<b>Model</b>	C4MF	<b>Volt/Hz</b>	<b>Date of Modification</b>	<b>Serial Number</b>
<b>Modified Article</b>	Parts Catalog			
<b>Reason for Modification</b>	Parts catalog correction

MODEL NAME	V/Hz	DESTINATION	CODE	SERIAL NUMBER
Ricoh DS5330	115/60	U. S. A.	A099-17

Page 108

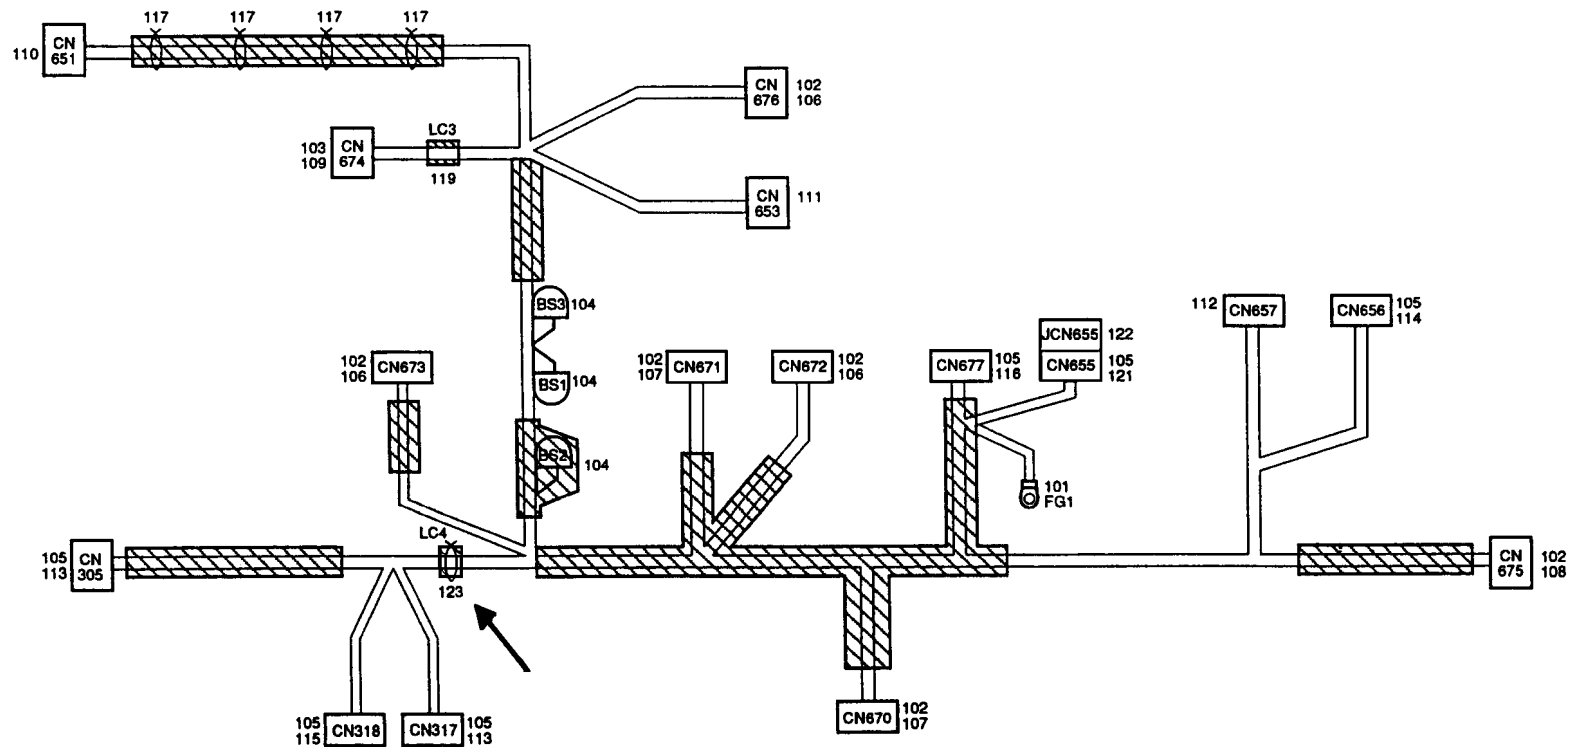
5. Please add the following parts to your parts catalog:

P/N	Description	Parts Catalog	
		Index No.	Page
11040511	IC Socket - 8P-D1CF-8CS-E	175	111
14074263	DRAM Module - 4MB	176	111
16303203	Resistor - 20K $\Omega$ $\pm$ 5% 1/10W	160	119
11050047	TY - Wrap	123	129

SYMBOL NO.	INDEX NO.	SYMBOL NO.	INDEX NO.	SYMBOL NO.	INDEX NO.
IC11	145	IC21	146	IC30	135
IC12	13	IC22	9	IC31	135
IC13	140	IC23	8	IC32	135
IC14	3	IC24	6	IC33	135
IC15	4	IC25	5	IC34	135
IC16	11	IC26	144	IC35	112
IC17	10		113	IC36	112
IC18	12	IC27	135	IC37	137
IC19	1	IC28	135	IC38	20
IC20	15	IC29	135	(Socket)	110

SYMBOL NO.	INDEX NO.	SYMBOL NO.	INDEX NO.	SYMBOL NO.	INDEX NO.
IC11	145	IC21	146	IC31	135
IC12	13	IC22	9	IC32	135
IC13	140	IC23	8	IC33	135
(Socket)	175	IC24	6	IC34	135
IC14	3	IC25	5	IC35	176
IC15	4	IC26	144	(Socket)	112
IC16	11	(Socket)	113	IC36	176
IC17	10	IC27	135	(Socket)	112
IC18	12	IC28	135	IC37	137
IC19	1	IC29	135	IC38	20
IC20	15	IC30	135	(Socket)	110

Parts Catalog page 32

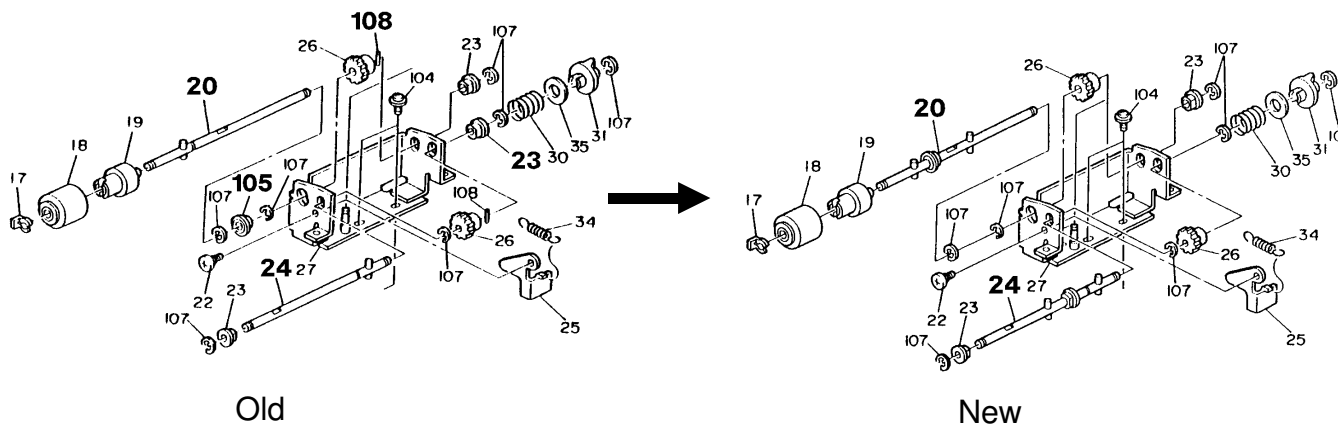
The cylindrical pins on the reverse roller drive shafts of the side, the first and the second feed station have been changed to the spring pins. To facilitate servicing, the assembled parts will be supplied as service parts in stead of the individual parts as shown below.

**DETAILS OF MODIFICATION****2. Illustration corrections**IncorrectCorrect

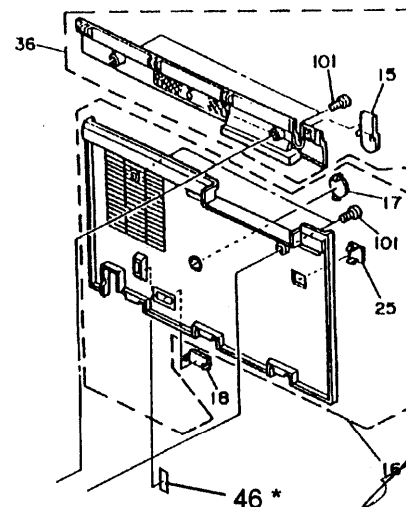
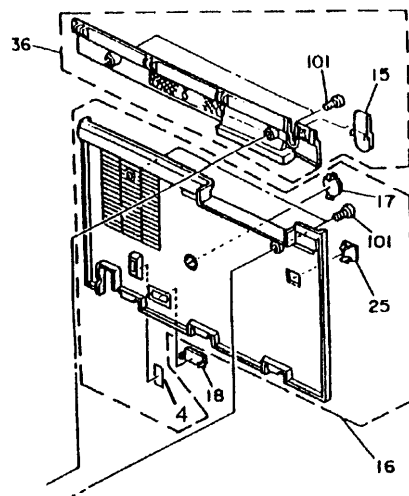
Incorrect P/N	Incorrect Description	Correct P/N	Correct Description	Parts Catalog	
				Index No.	Page
<b>A0061315</b>	<b>Decal - Main SW- 115F</b>	<b>AA001375</b>	Decal - Main SW- Standby	4	13
A0061315	Decal - Main SW- 115F	AA001374	Decal - Switch - On /Off	46*	13
A0061316	Decal - Main SW- 220/240F	AA001375	Decal - Main SW- Standby	4	13

\*: New index number (Refer to the following illustration corrections.)

Note: The decal (#4) is not included in the left cover assembly (#1).

Note: The decal (#46) is not included in the rear cover assembly (#16).

2. Illustration corrections

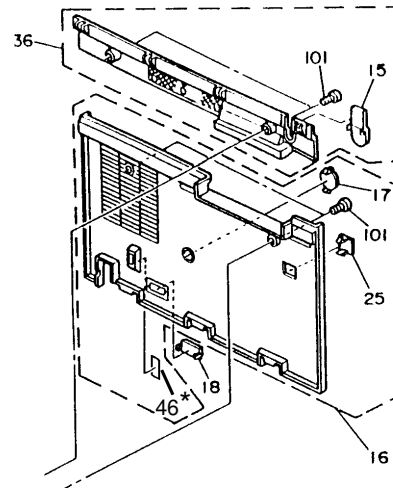
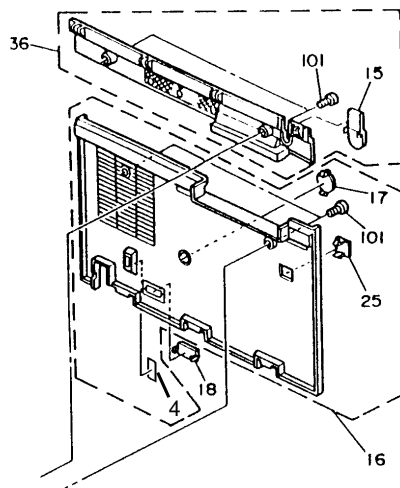
Incorrect P/N	Incorrect Description	Correct P/N	Correct Description	Parts Catalog	
				Index No.	Page
A0061315	Decal - Main SW - 115F	AA001375	Decal - Main SW - Standby	4	13
A0061316	Decal - Main SW - 220/240F	AA001375	Decal - Main SW - Standby	4	13
A0991290	Rear Cover	A0991291	Rear Cover - 220/240V	16	13
A0061316	Decal - Main SW - 220/240F	A0061315	Decal - Switch - On/ Off	46 *	13

\* : New index number (Refer to the following illustration corrections.)

Note: The decal (#4) is not included in the left cover assembly (#1).
